NEW GAS STATION, C-STORE, DRIVE-THRU
A.L. PRIME #TBD
23 CENTRAL STREET
BYFIELD, MASS

THIS SET ISSUED FOR SPR & SP 10/7/20 2nd HRG, W/ REVISIONS PER CMTS

PROJECT
COVER SHEET

**SELF SERVICE
FIRE SUPPRESSION**

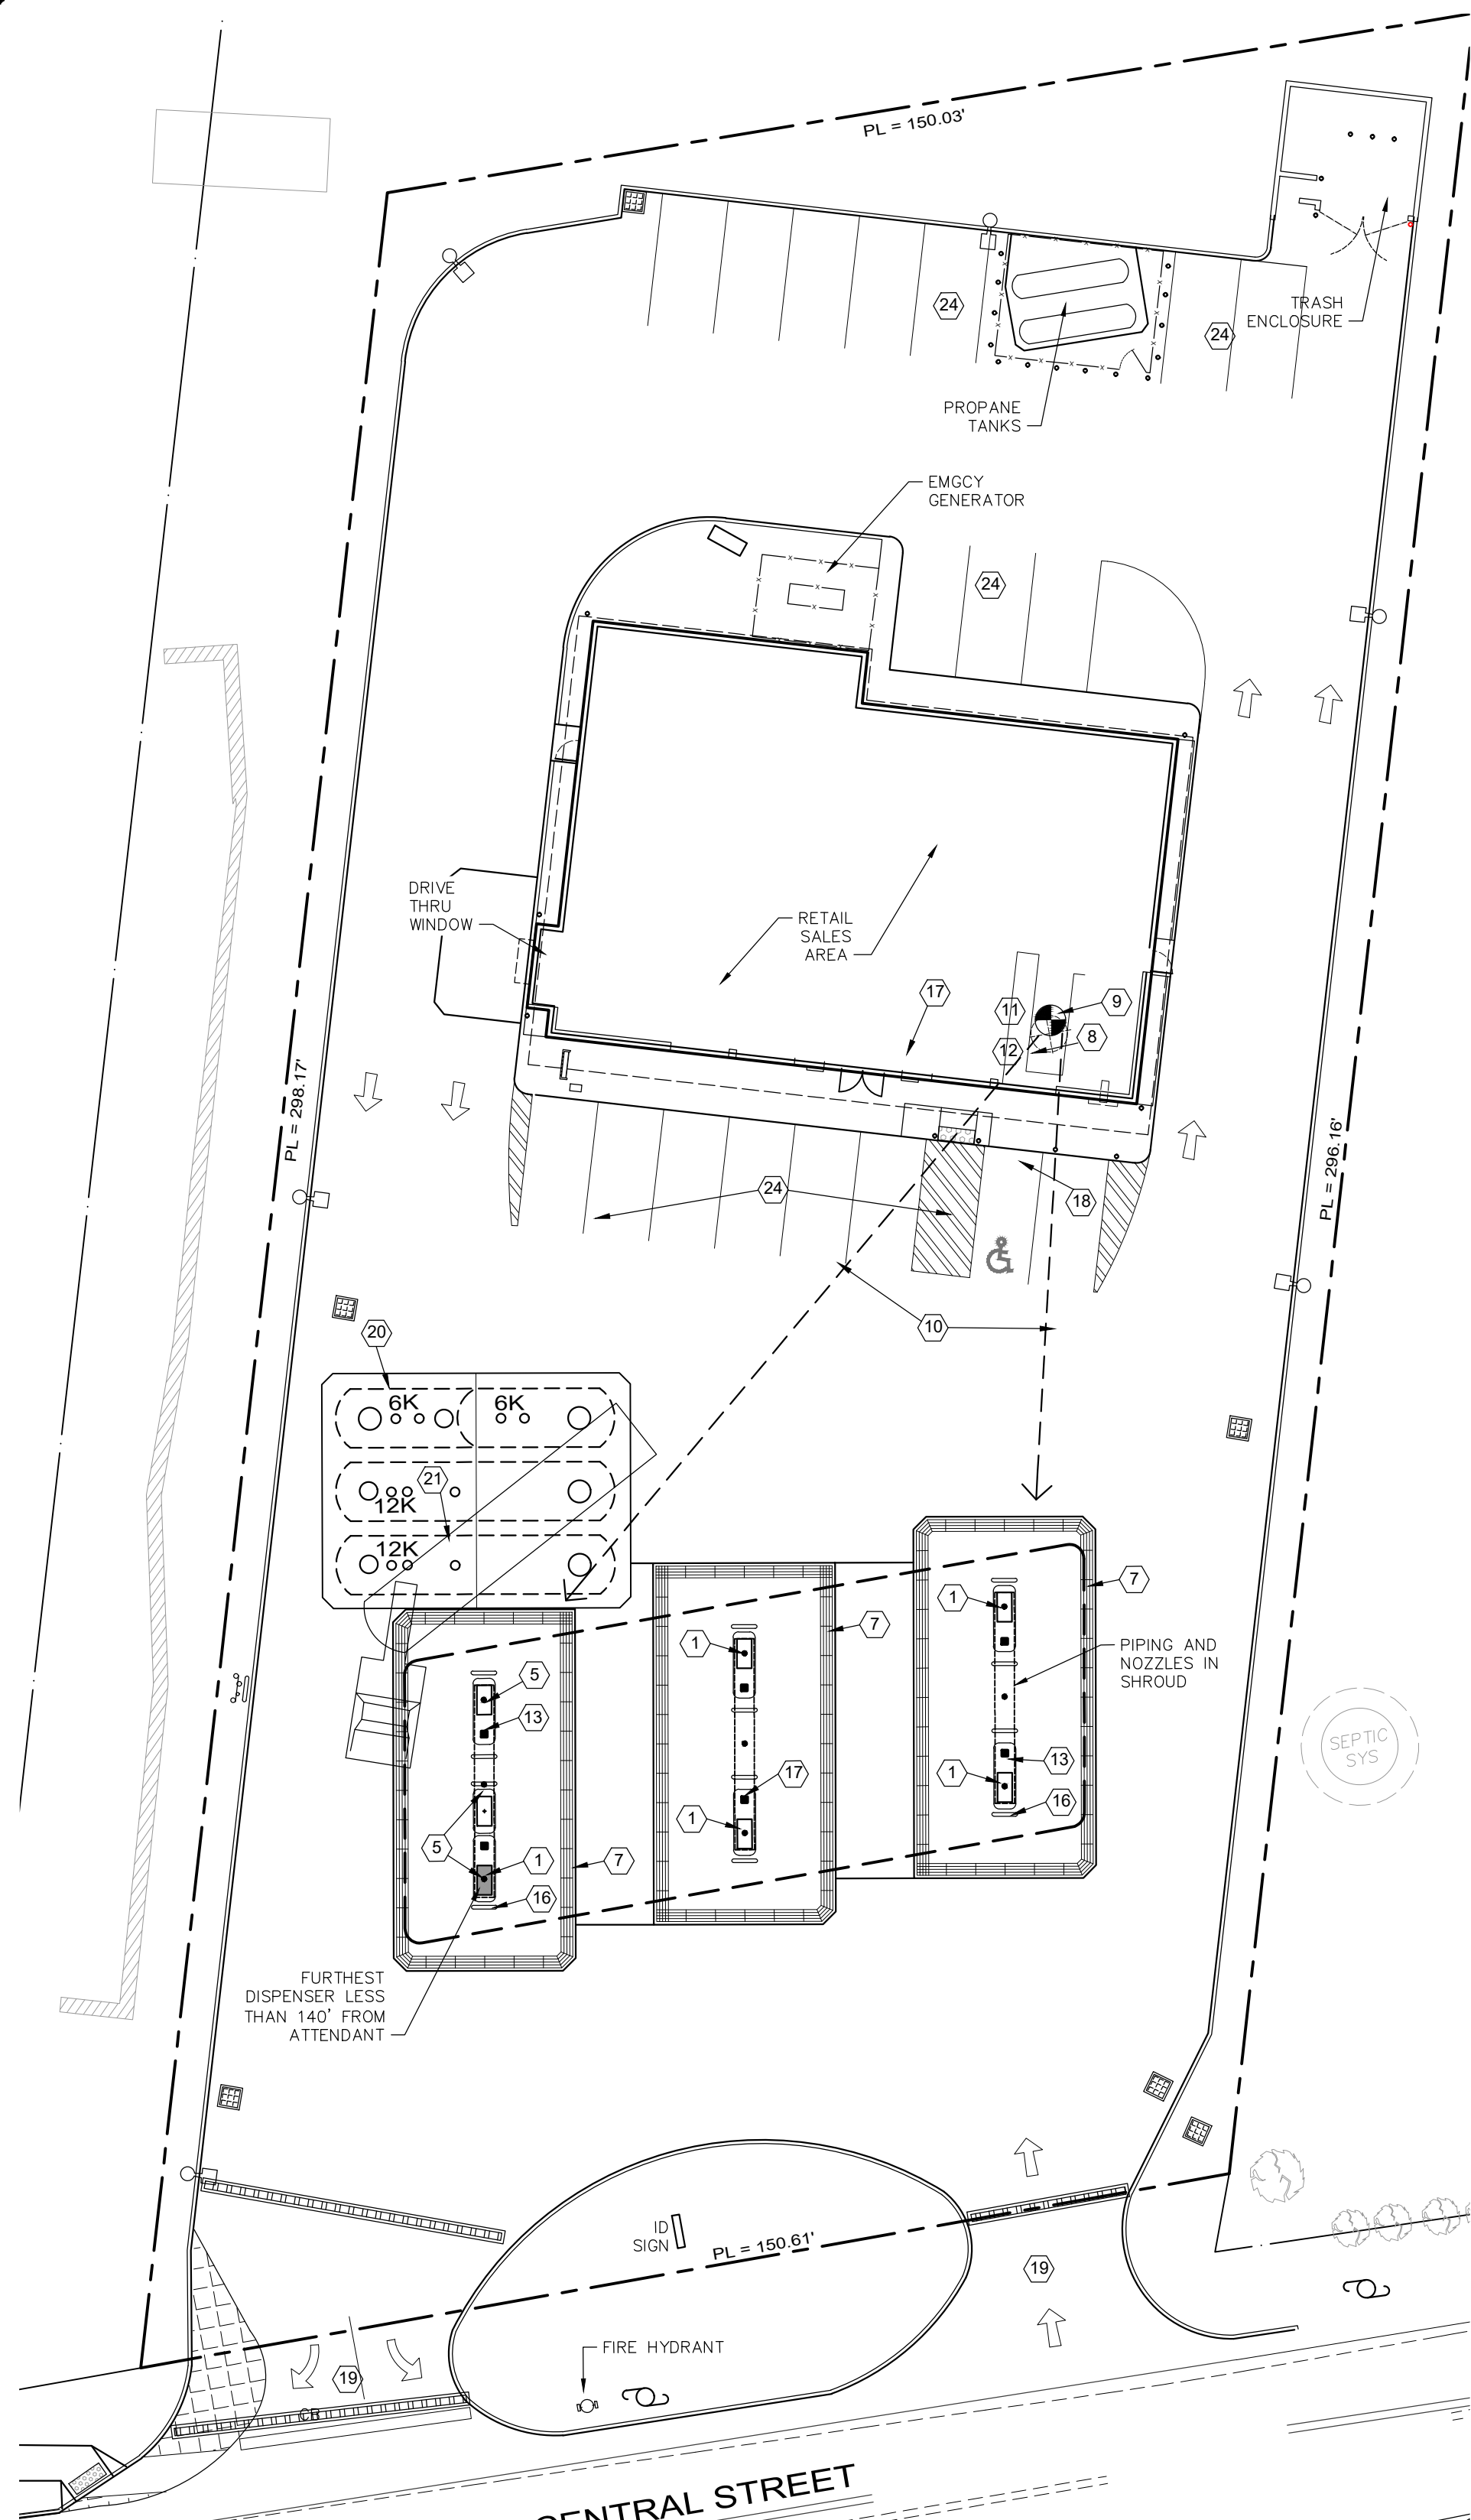
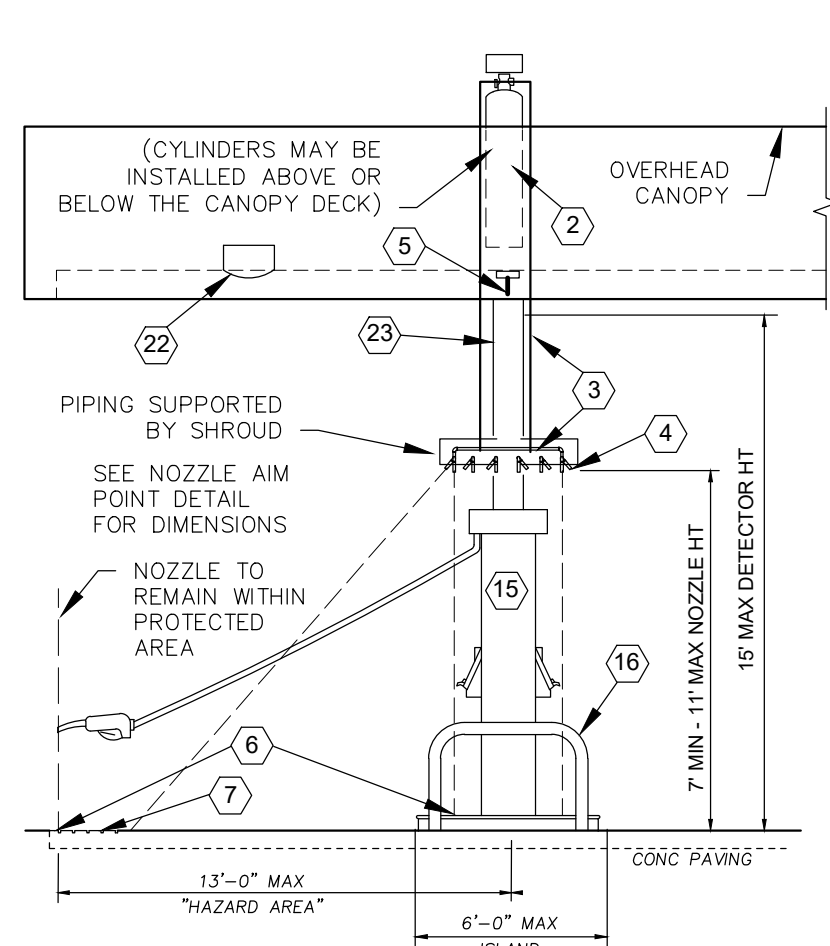
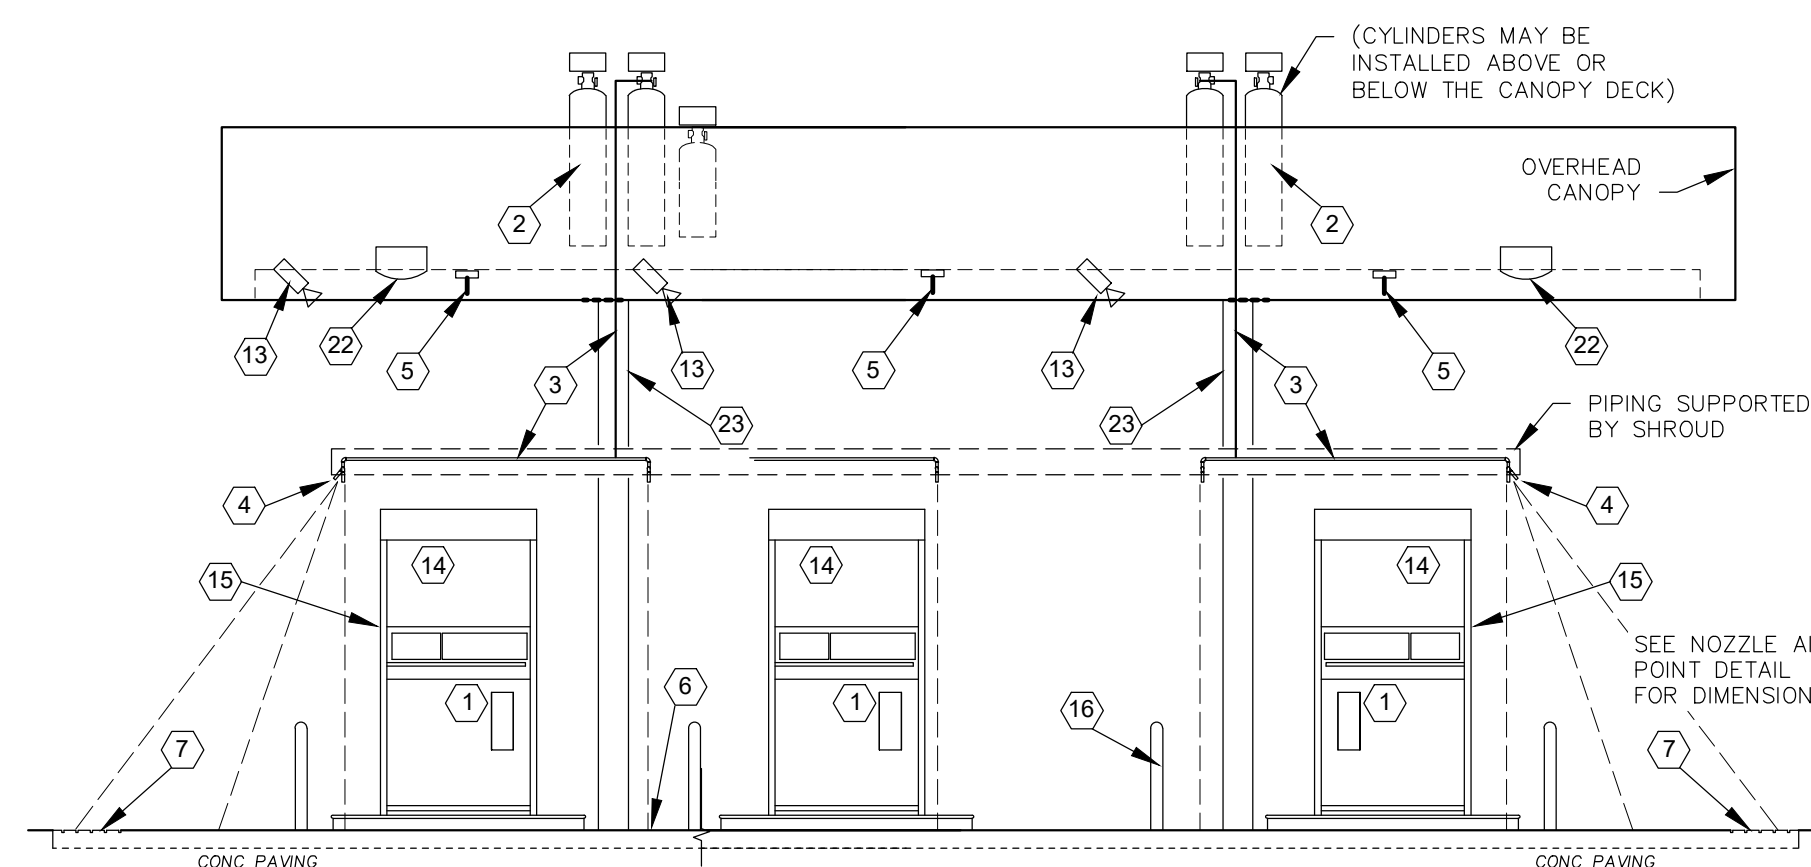
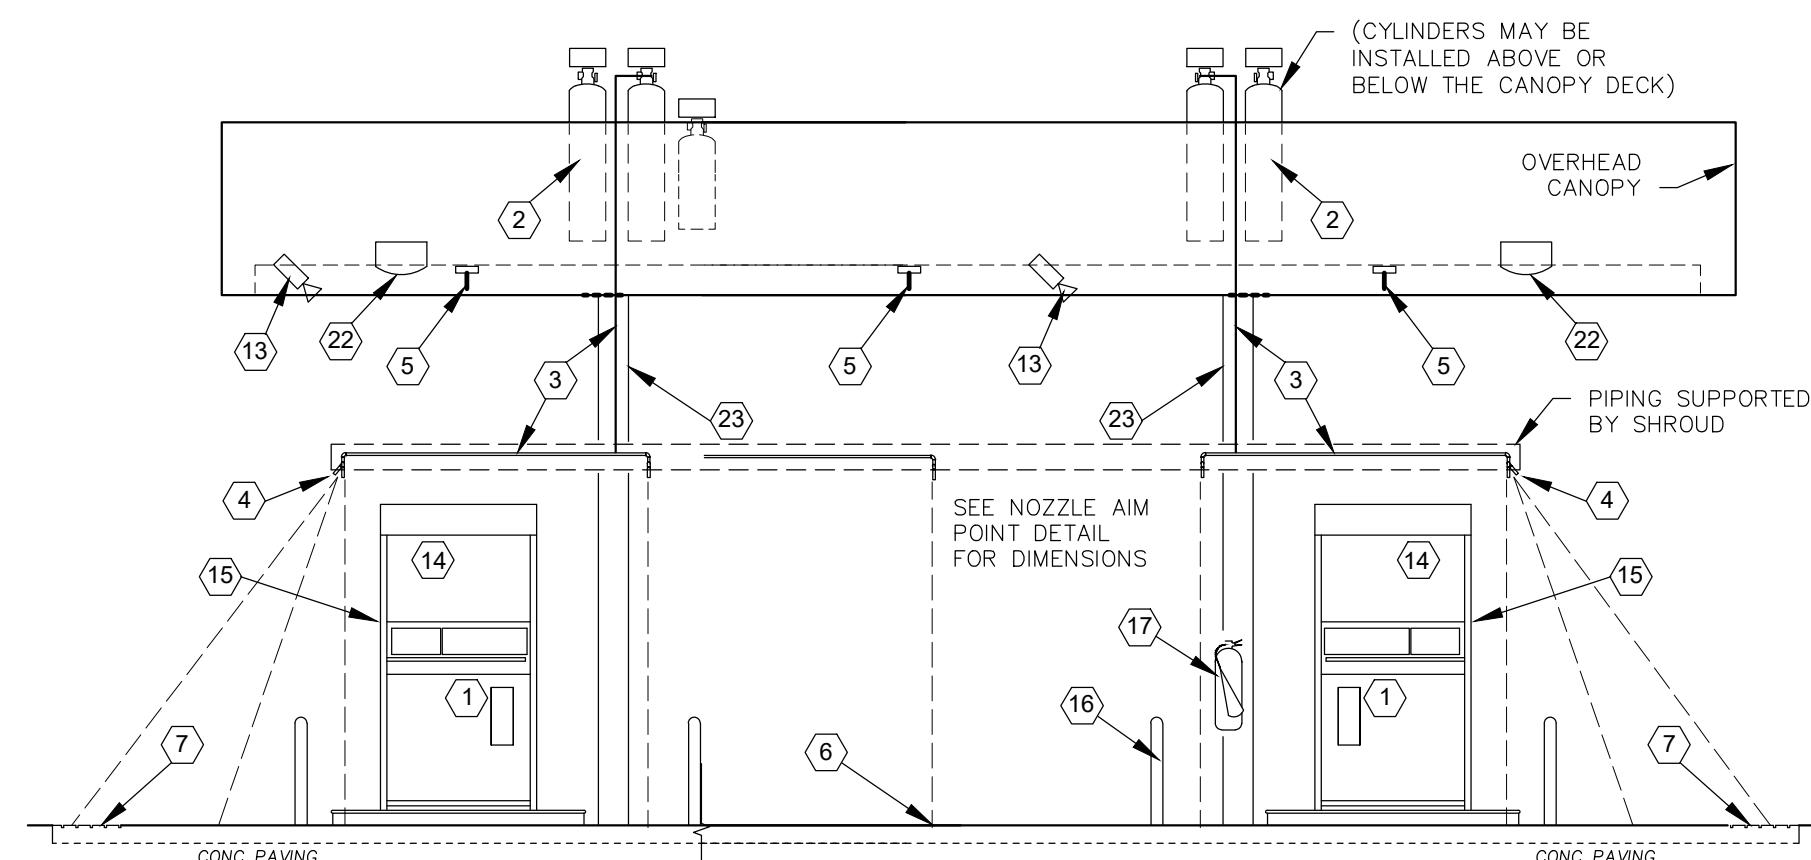
| DATE | BY | DESCRIPTION |
|-------------|------|---|
| 23 SEP 2020 | 1 AG | ADDED NOTE PER FD COMMENTS FOR MONITORED FIRE ALARM |

BYFIELD FIRE DEPT REQUIREMENT
A MONITORED BUILDING FIRE ALARM PANEL WILL BE INSTALLED AND THIS FIRE SUPPRESSION SYSTEM WILL BE ADDED TO THE PANEL AS A SEPARATE ZONE

FLOOR PLAN

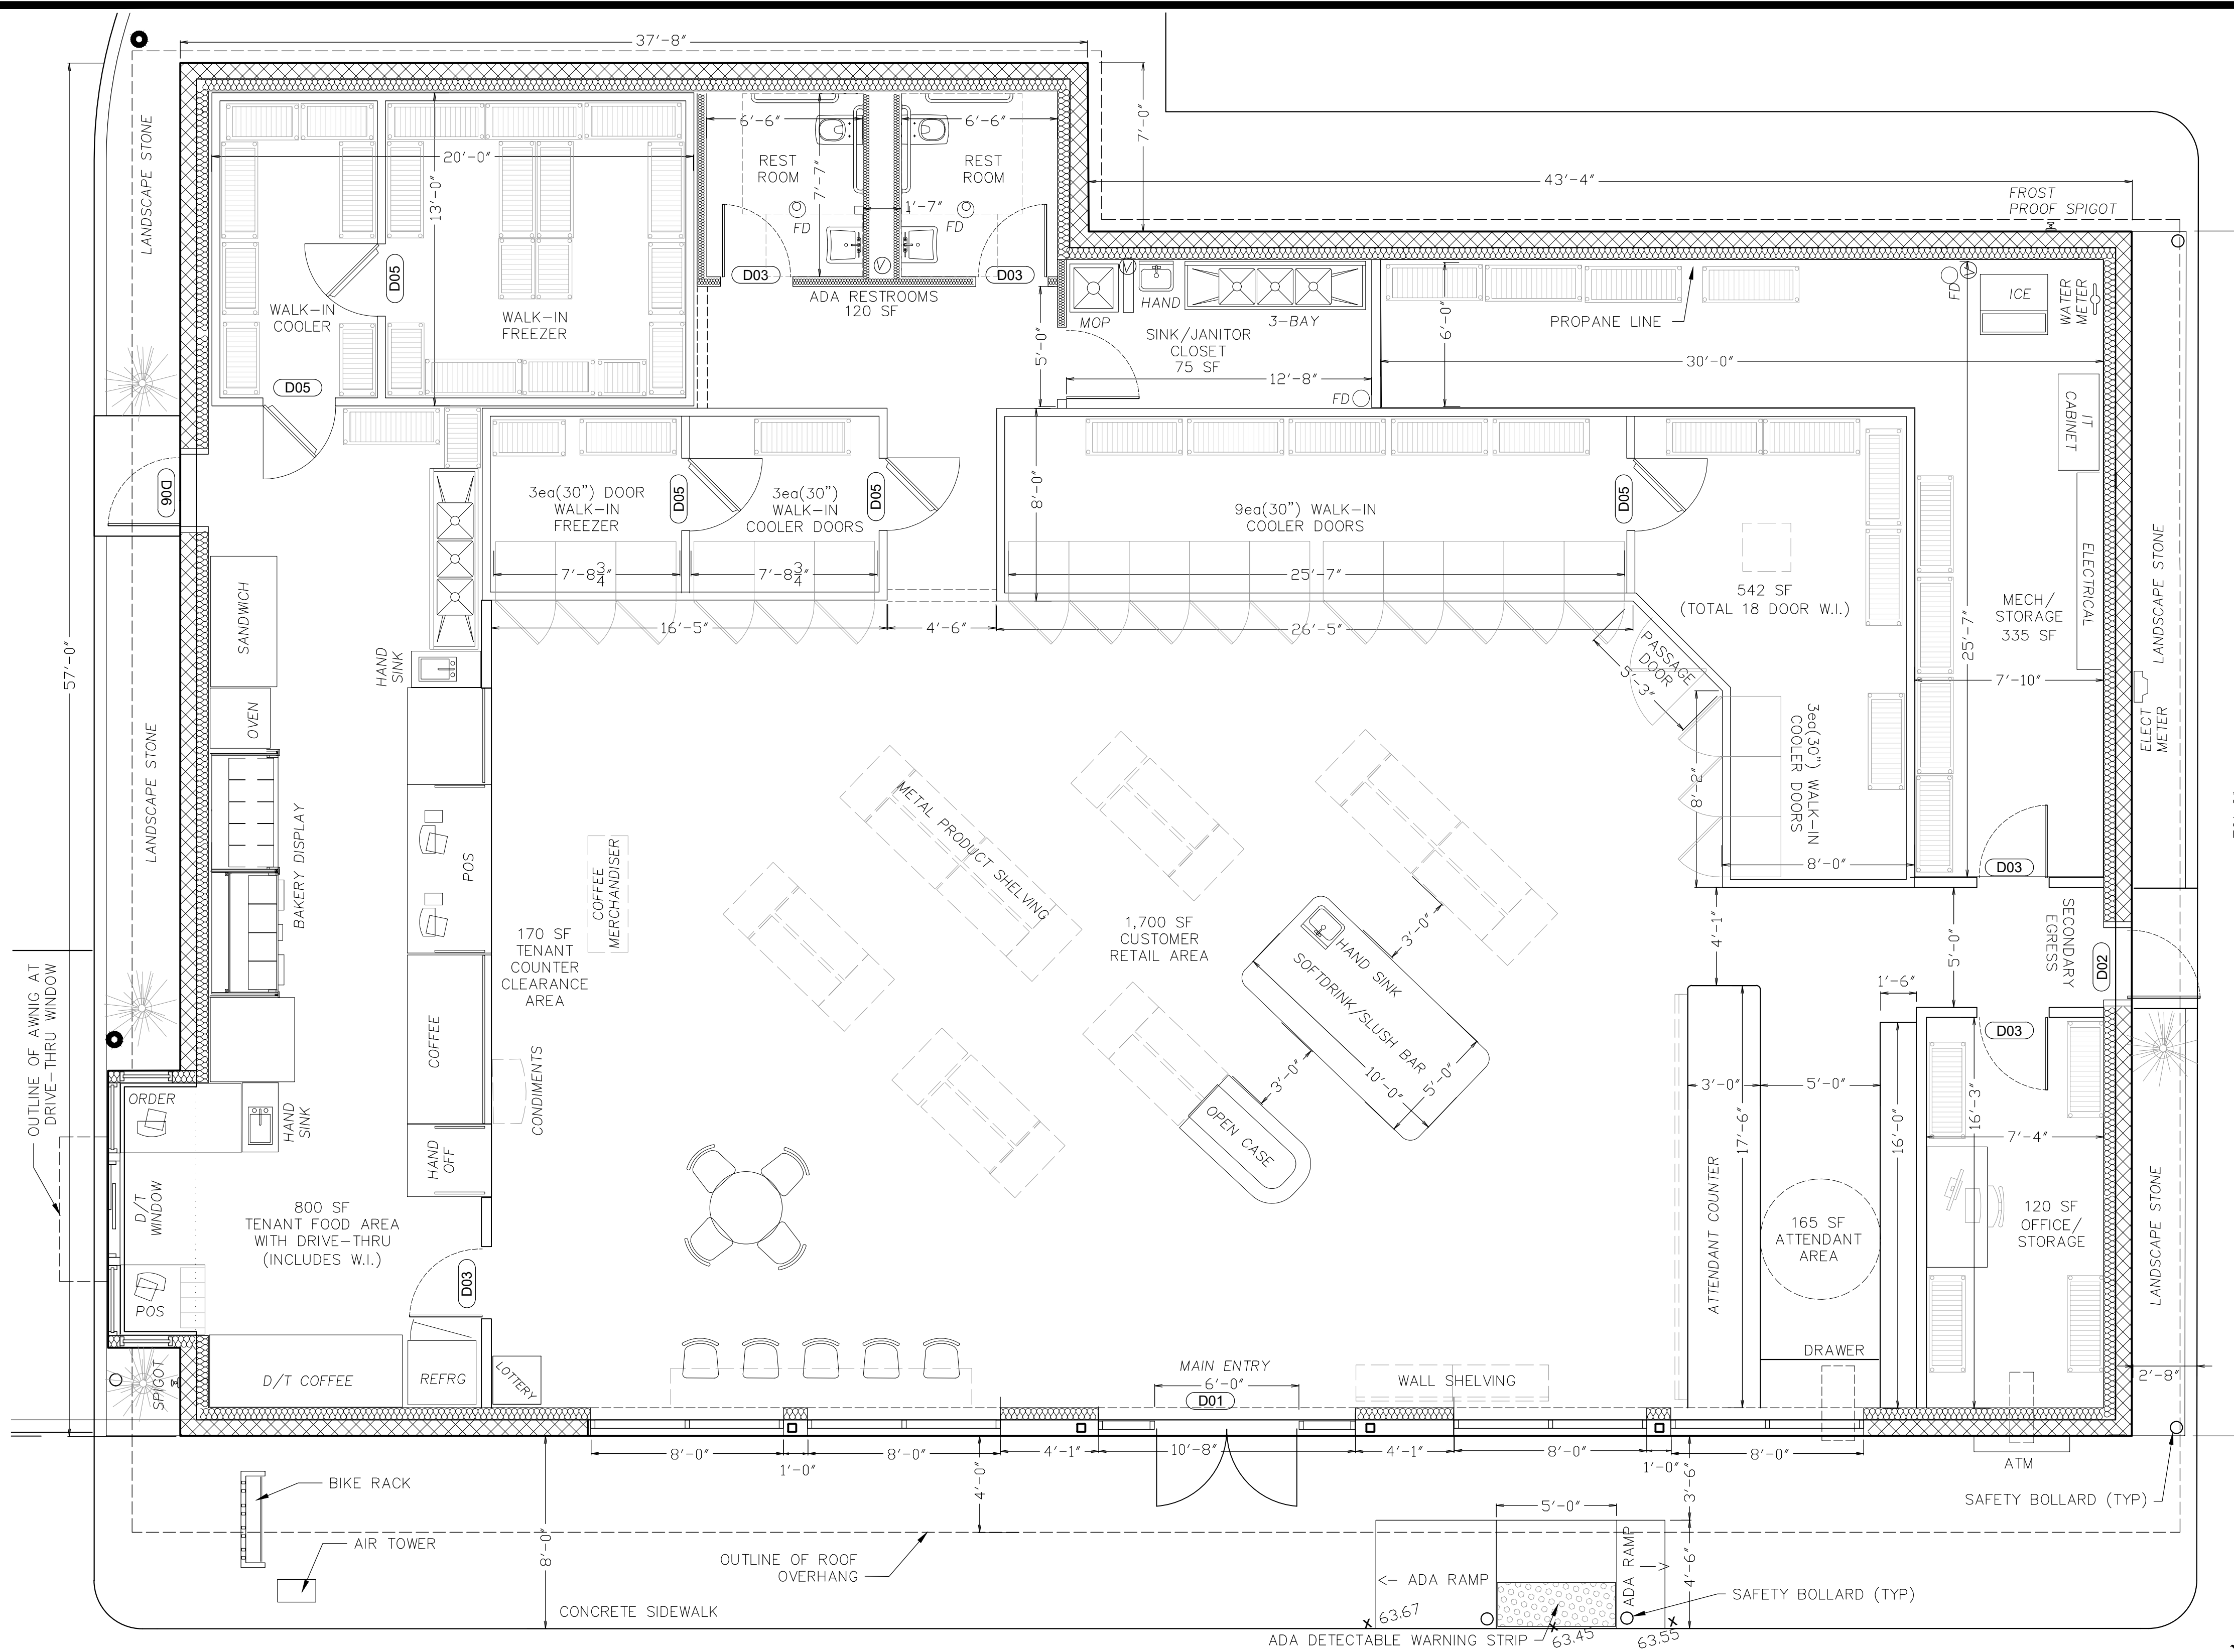
PLAN REVISIONS 23 SEPT 2020

1. CHANGED LOCATIONS OF WATER AND ELECTRIC METERS
2. OVERHANG CHANGED FROM FLAT ROOF FASCIA STYLE
3. ADJUSTED ADA SIDEWALK RAMP
4. ADDED BIKE RACK AND AIR TOWER ON SIDEWALK
